STATE OF NORTH CAROLINA  
DEPARTMENT OF TRANSPORTATION

**SUBJECT:** Request For NW 23/33 Permit Modification and NW 13 for the replacement of Bridge No. 122 over Sandy Creek and Bridge No. 217 over a tributary to Sandy Creek on SR 1116 in Durham County, Federal Project No. BRSTP-1116 (4), State Project No. 8.2353001, Division 5, WBS Element 33070.1.1, T.I.P. No. B-3450.

The North Carolina Department of Transportation (NCDOT) proposes to modify the Section 404 Nationwide Permits (NWP) previously issued for construction of this project and add a NWP 13. This proposed permit modification application specifically reflects construction revisions at Bridge 217 over an Unnamed Tributary (UT) to Sandy Creek on SR 1116 (Garrett Road) in Durham County. The project is located in the Cape Fear River basin. Please note that Revised Permit Drawings 3, 4 and 8 of 8 are attached to this submittal.

**ON SR 2220** *Revised*  
**SHEET 3 OF 8** **1/16/2008**

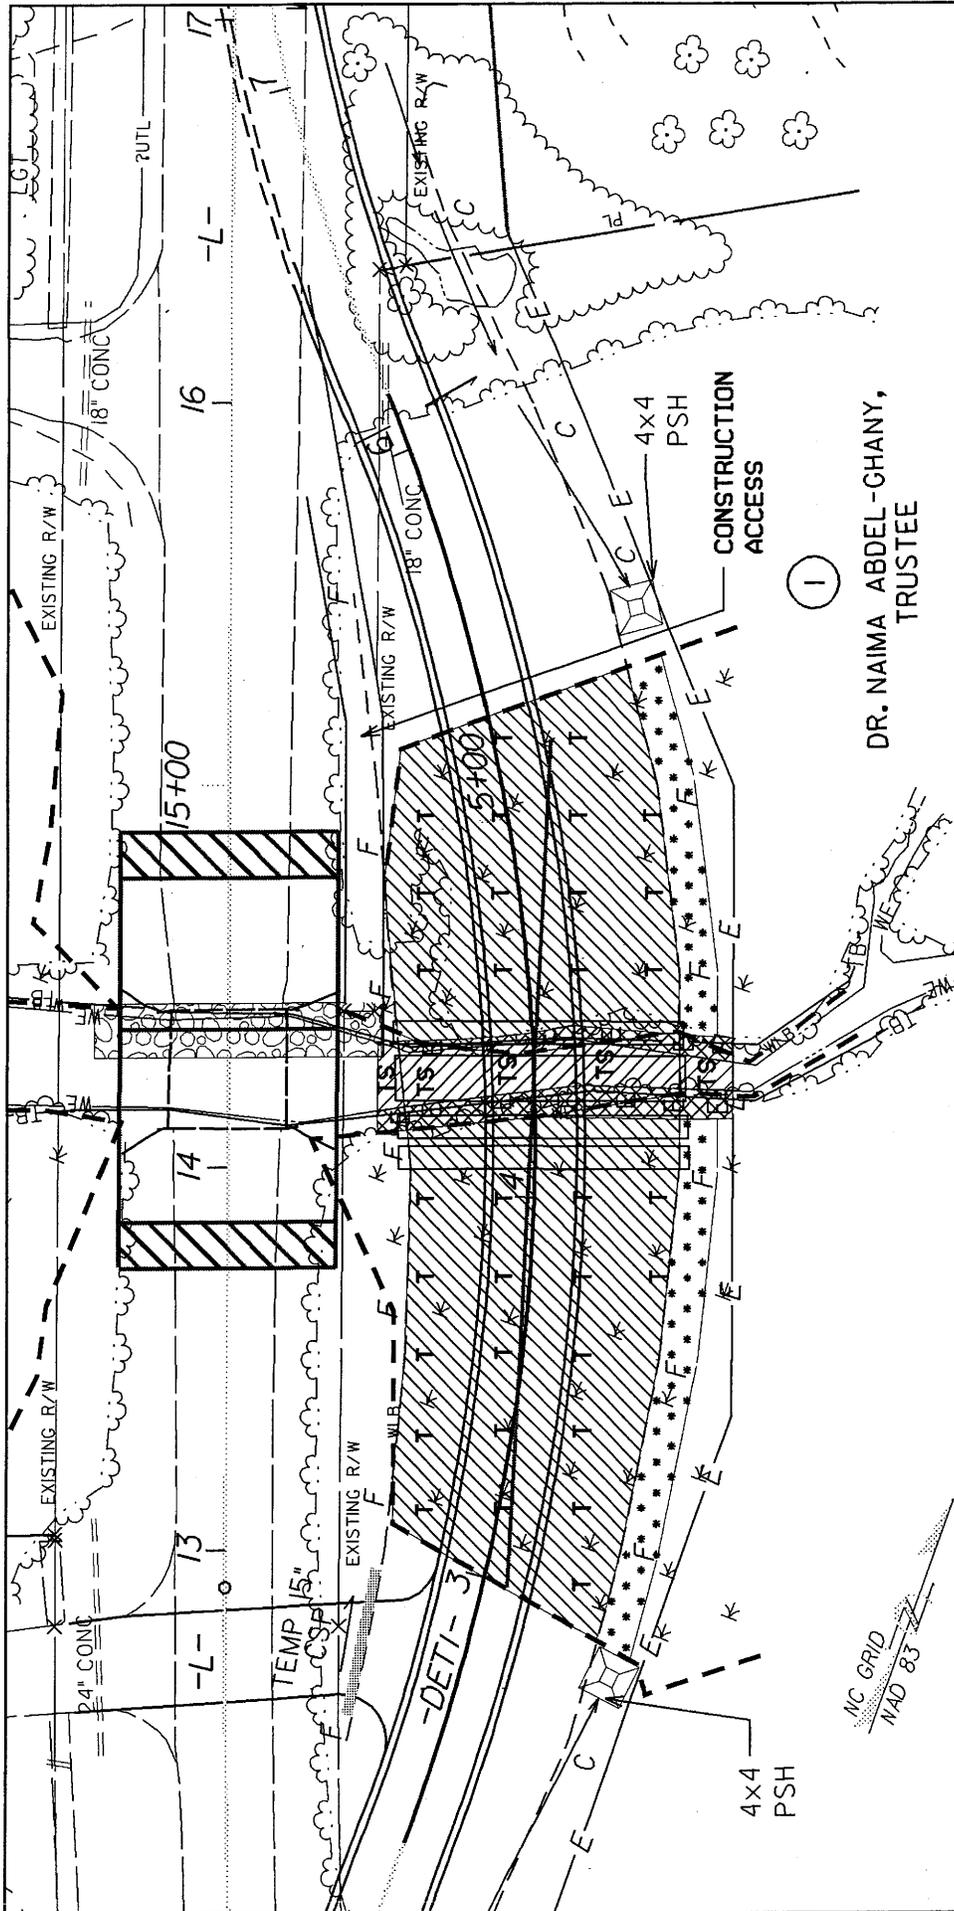
PFSH located at 13+30 Lt will be increased from a 6' x 6' device to a 12' x 12' device. The PFSH located at 15+57 Lt will be increased from a 4' x 4' devices to a 6' x 6' device. The construction of the devices will result in additional impacts to wetlands.

Jurisdictional changes: The construction revision will result in new impacts of 0.003 excavation in wetlands and an increase of 0.02 acres mechanized clearing in wetlands.
